Access Compliance Report

Public Rights-of-Way

(Curb Ramps)

Intersection ID: 11956	Main Street: E_9TH_ST	Cross Street: N_COLLEGE_ST	Location: N
ADA ID: 6F6EE0AFBDDE	Ramp Type: PerpDiag	Initial Pass/Fail: Fail	Overall Compliance: No
		Severity Score: 12.5

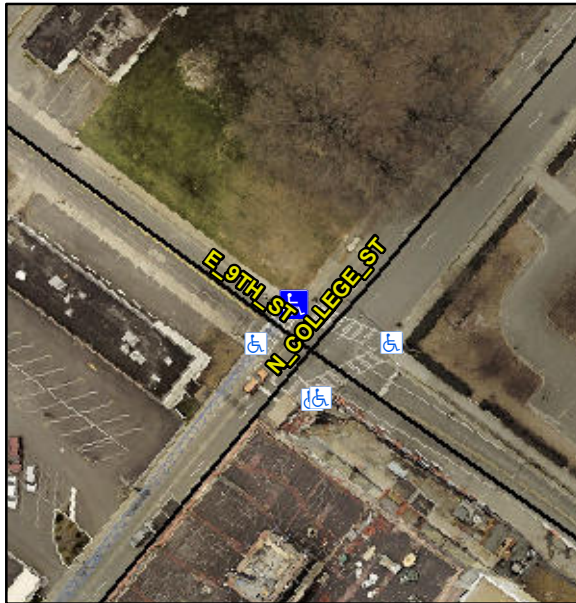
Not Found, R304.2.2

Compliance	Description	Data	Compliance	Description	Data
N/A	Ramp Length (in)	51.0	No	Ramp Slope (%)	9.1
Yes	Ramp Width (in)	48.0	Yes	Ramp XSlope (%)	0.9
N/A	Flare Type LT	N/A	N/A	Flare Type RT	N/A
N/A	Flare Slope LT (%)	N/A	N/A	Flare Slope RT (%)	N/A
N/A	Flare Traversable LT?	N/A	N/A	Flare Traversable RT?	N/A
N/A	Landing Length (in)	N/A	N/A	DWS Provided?	N/A
N/A	Landing Width (in)	N/A	N/A	DWS Contrast?	N/A
N/A	Landing Slope (%)	N/A	N/A	DWS Length (in)	N/A
N/A	Landing X Slope (%)	N/A	N/A	DWS Full Width?	N/A
N/A	Landing Curb? (Y/N)	N/A	N/A	DWS Offset (in)	N/A
N/A	Shared Landing?	N/A			
N/A	Gutter Ponding?	Yes	N/A	Gutter Slope (%)	N/A
N/A	Gutter Lip Ht (in)	N/A	N/A	Gutter X Slope (%)	N/A
N/A	Painted X Walk1?	Yes	N/A	Painted X Walk2?	Yes
	X Walk 1 Direction	To SW		X Walk 2 Direction	To SE
N/A	X Walk 1 Width (in)	95.0	N/A	X Walk 2 Width (in)	95.0
	X Walk 1 Slope (%)	2.9		X Walk 2 Slope (%)	2.6
	X Walk 1 X Slope (%)	1.3		X Walk 2 X Slope (%)	0.0

Remove & Replace Curb Ramp With Two New Directional Ramps or Equivalent.
